### APPEAL SUMMARY

**Appeal ID:** 20510

**Project Address:** 431 SW Colony Dr

**Case No.:** B-014

**A1.0**

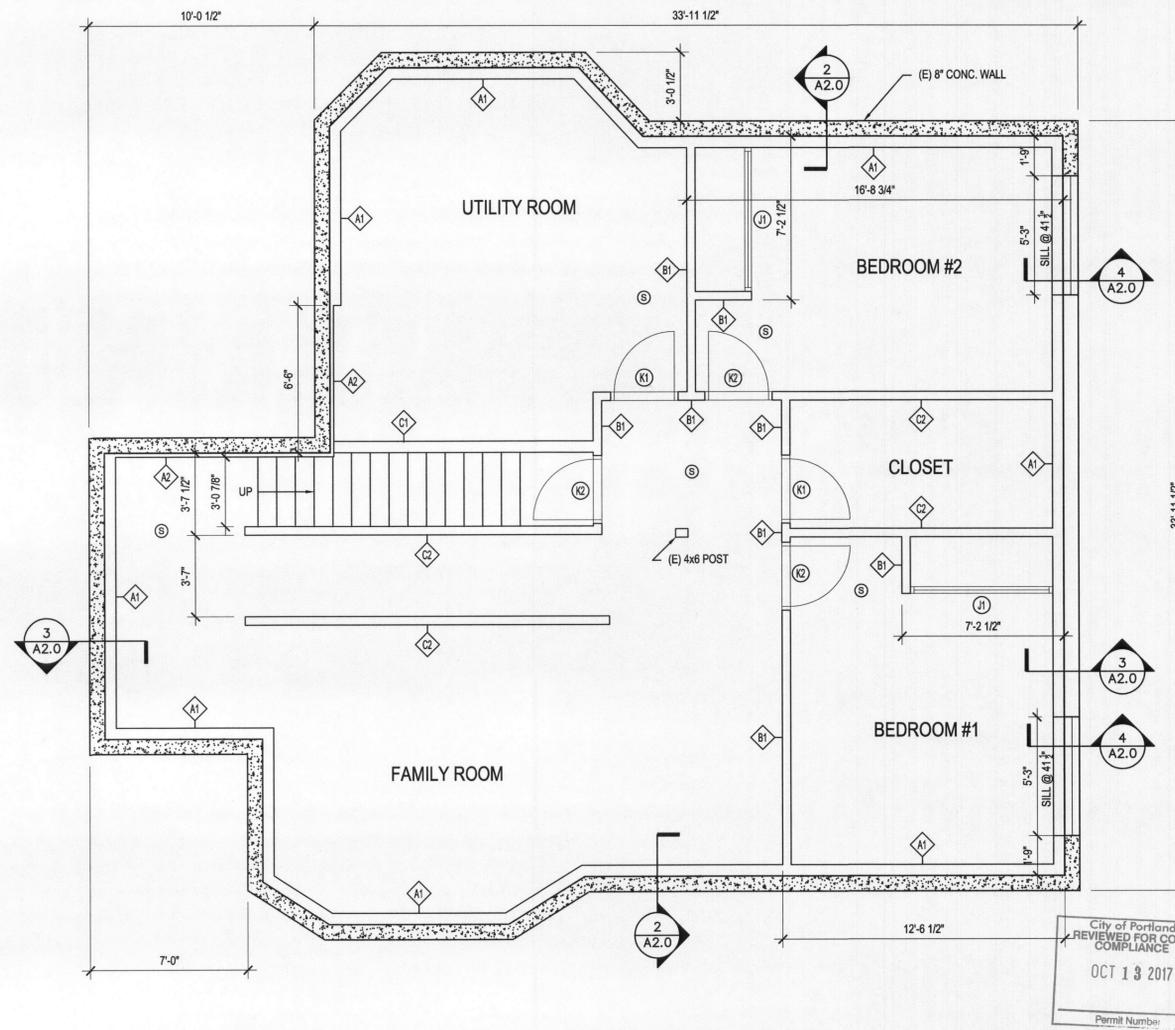
**Code Section** R311.7.5.1

**Requires** The greatest riser height within any flight of stairs shall not exceed the smallest by more than 3/8 inch (9.5 mm).

**Proposed Design** The stairs as shown on the permit plans as filed are existing, built as part of the original home construction permit. The treads and risers have been refinished as part of the overall basement renovation project. No modifications have been made to the overall stair structure, joists or stringers.

**Reason for alternative** Of the 14 existing steps, only (1) exceeds the smallest step rise by 1/2". This is a variance of 1/8" (0.125") from the allowable 3/8" (0.375"). All other existing (13) steps are in compliance. The existing stair well far exceeds the code minimum requirements. The width is in excess of 40", clear head height of 7'+, adequate lighting, and all tread depths and nosing are also in compliance. Additionally, a code compliant handrail has been added where one had not previously existed to additionally improve the overall safety of the stairway. We would like to request the inspection report from 4/15/19 be reconsidered and the stairs considered within compliance upon final inspection.

**Increase in maximum stair riser variation to 1/2 inch at one location: Granted provided handrails are installed on both sides of the stair.**
